Service Manual

KX-TC1282JXB

Please file and use this supplement manual together with the service manual for Model No. KX-TC1282JXB, Order No. KM40201814C3.

1.2. ORIGINAL AND NEW PARTS COMPARISON LIST

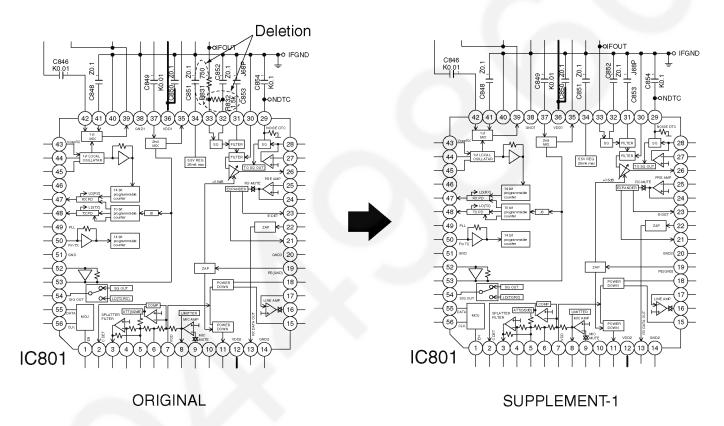
Suffix Code	Reasons of change
A→B	For Bell sound.

Ref. No.	Par	t No.	Part Name & Description		Pcs/	Remarks	Notes		s Time of Change
	Original (Old)	New			Set				(Suffix)
BASE UNIT	BASE UNIT								
IC301	C2HBBH000040	C2HBBH000046	IC		1	а	4	٧	B→C
	C2HBBH000046	C2HBBH000055	IC		1	а	4	٧	C→D
HANDSET									
103	PQGP10189Z1	PQGP10222Z1	LCD Panel		1	а	4	V	-
109	PQHX11034Z	PQHX11034R	Pet Sheet		1	а	4	Х	-
R708	ERJ3GEYJ4R7	ERJ3GEYJ270	Resistor, 27Ω	*1	1	b	1	Х	A→B
R710	PQ4R10XJ120	PQ4R10XJ000	Resistor, 0Ω	*1	1	b	1	Х	A→B
R831	ERJ3GEYJ751		Resistor, 750Ω	*2	0	а	6	-	-
R832	ERJ3GEYJ152		Resistor, 1.5kΩ	*2	0	а	6	1	-
R903	ERJ3GEYJ184	ERJ3GEYJ154	Resistor, 150kΩ		1	С	1	Х	-
